STAFF COMMENTS

HEARING DATE: July 23, 2024

A-24:149 – 56 York Road, Dundas

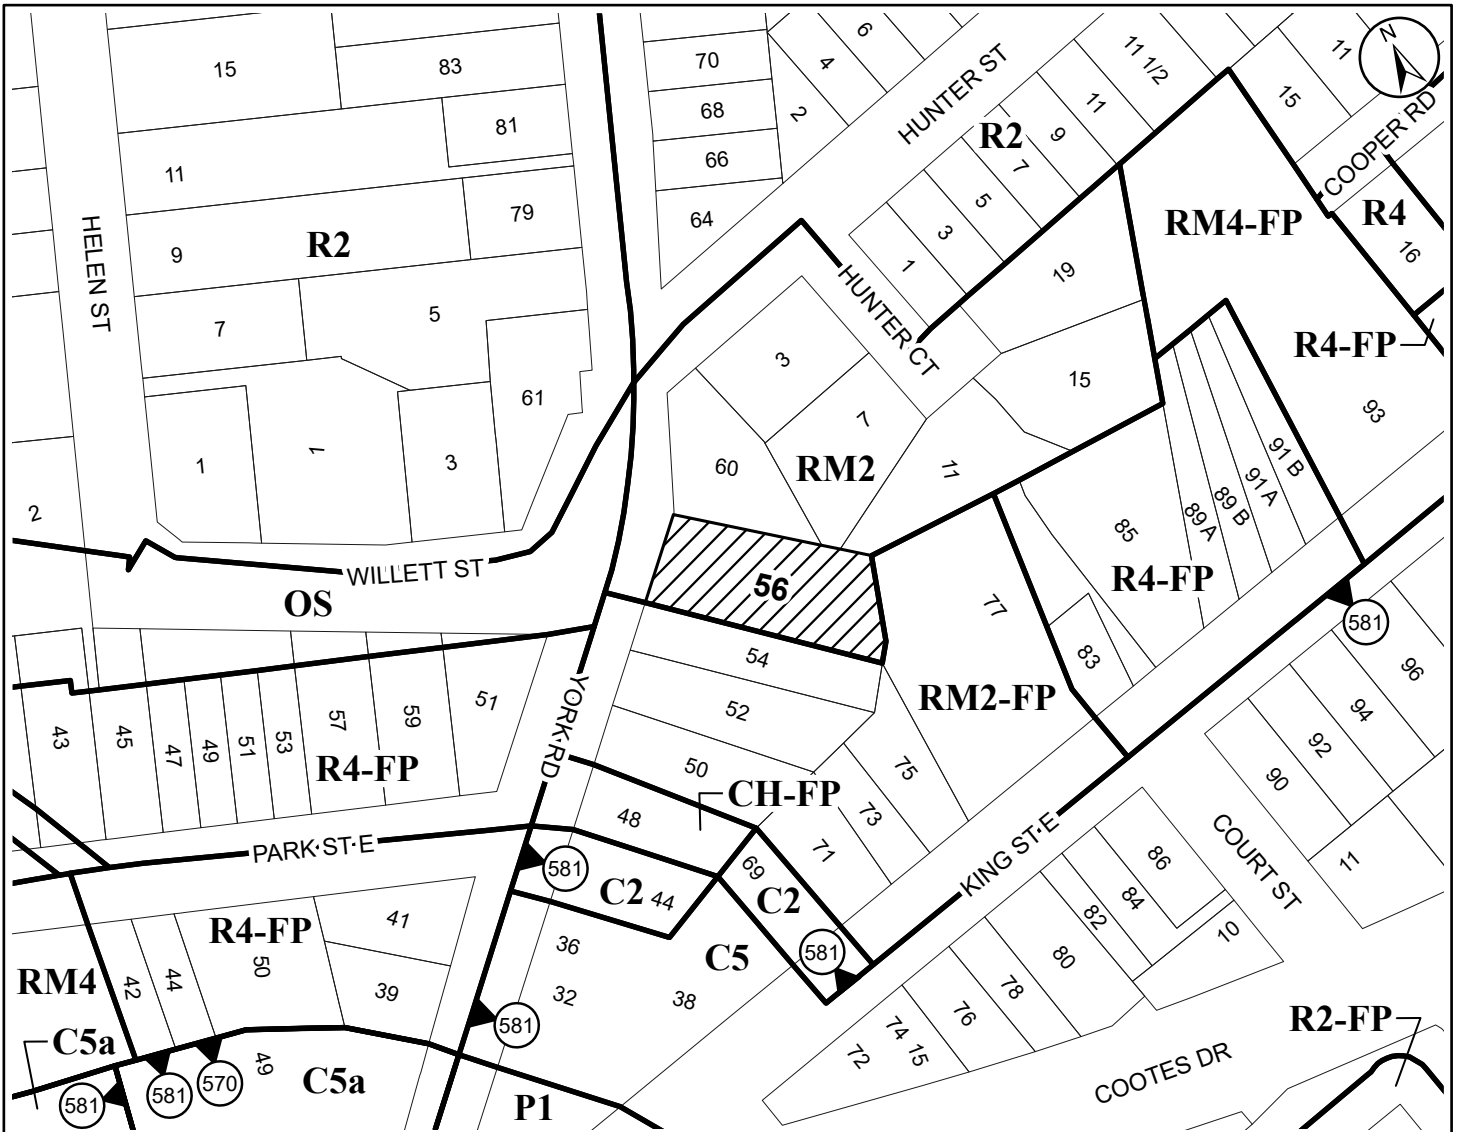
- Minimum 4m horizontal clearance from existing O/H line(s) must be maintained at all times as per Alectra Utilities Standard 3-105. Please consult with Alectra Utilities if further clarification is required.

- CALL BEFORE YOU DIG, arrange for underground hydro cable locate(s) before beginning construction by contacting Ontario One Call @ 1-800-400-2255.
- Clearances from Overhead and Underground existing electrical distribution system on our adjacent to the property must be maintained in accordance to:

- UNDER NO CIRCUMSTANCES SHALL A CONDUCTOR BE PERMITTED TO PENETRATE THE ENVELOPE SHOWN BY THE DOTTED LINE.

1. THIS CLEARANCE IS MADE UP OF A 1.0 m MINIMUM APPROACH CLEARANCE PLUS A 1.0 m ALLOWANCE FOR CONDUCTOR SWING. WHERE CONDUCTOR PASS IN FRONT OF A WINDOW OR OTHER OPENING, THIS 2.0 m CLEARANCE SHOULD BE INCREASED TO 2.5 m. WHERE BUILDINGS EXCEED 3 STOREYS OR 15.0 m IN HEIGHT, THE 2.0 m CLEARANCE SHOULD BE INCREASED TO 3.0 m TO ALLOW FOR RAISING OF LADDERS BY THE LOCAL FIRE DEPARTMENT.

2. THIS CLEARANCE IS MADE UP OF A 3.0 m MINIMUM APPROACH CLEARANCE PLUS A 1.0 m ALLOWANCE FOR CONDUCTOR SWING.
3. THIS DIMENSION PROVIDES 1.0 m MINIMUM APPROACH CLEARANCE FROM A 2.0 m TALL WORKMAN, PLUS A 1.5 m ALLOWANCE FOR CONDUCTOR SAG. (BASED ON AVERAGE SPAN OF 40 m)

4. THIS DIMENSION PROVIDES 3.0 m MINIMUM APPROACH CLEARANCE FROM A 2.0 m TALL WORKMAN, PLUS A 2.0 m ALLOWANCE FOR CONDUCTOR SAG. (BASED ON AVERAGE SPAN OF 40 m).

5. THE ABOVE CLEARANCES ARE MINIMUM VALUES. EFFORTS SHOULD BE MADE TO INCREASE THESE CLEARANCES ABOVE THOSE SHOWN, WHERE POSSIBLE. TO KEEP WORKMEN AND THEIR EQUIPMENT ON THE BUILDING ETC., AT THE MINIMUM CLEARANCE SHOWN, DIMENSION "X" AND "Y" ARE TO BE INCREASED BY THE REQUIRED WORKING DISTANCE.
